7.7 Control Systems Not Required for Safety

The information in this section of the reference ABWR DCD, including all subsections and figures, is incorporated by reference with the following departures and supplements.

Figure 7.7-11 Simplified Functional Diagram of the Automatic Power Regulation System

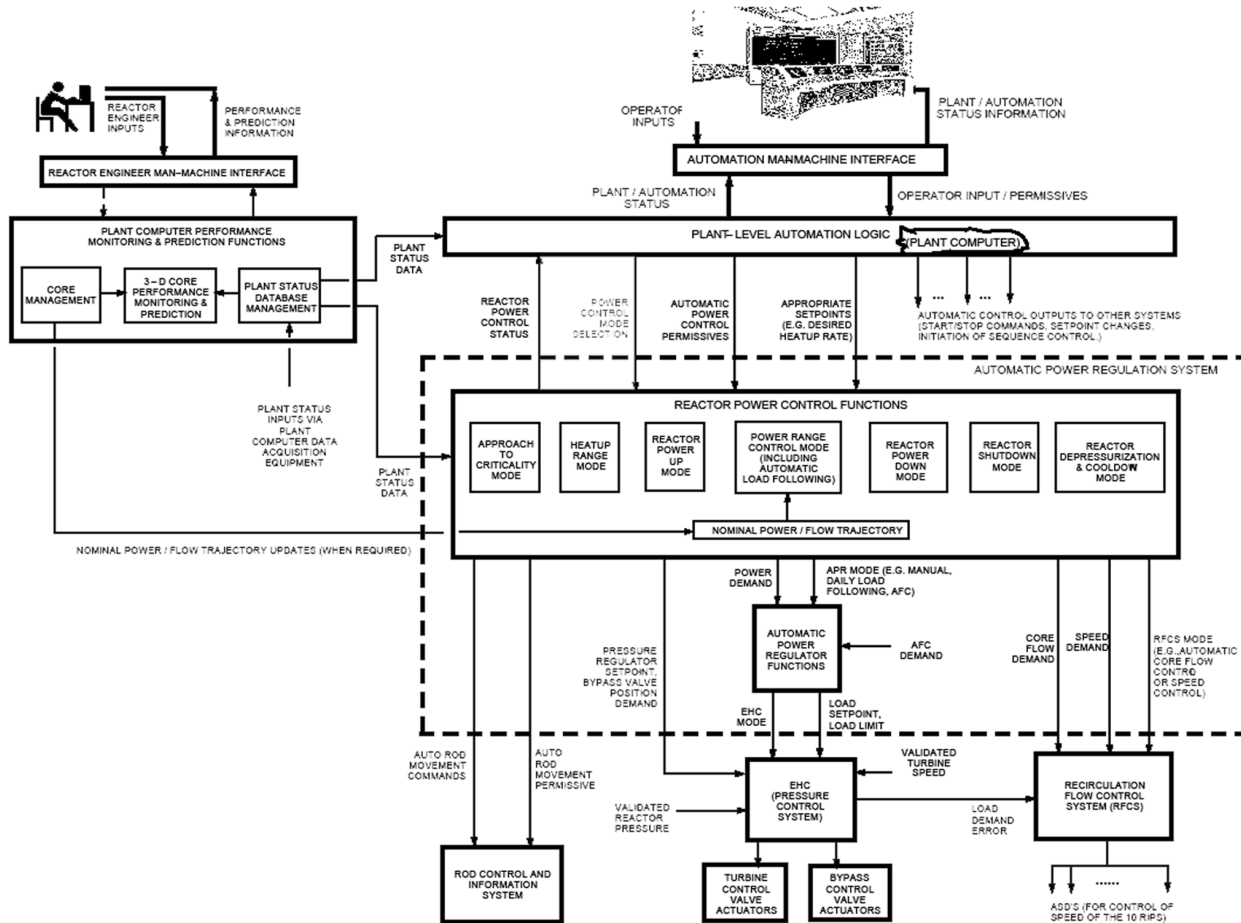
STD DEP T1 3.4-1 (Figures 7.7-2, 7.7-3, 7.7-4, 7.7-5, 7.7-7, 7.7-8, 7.7-9, 7.7-11)
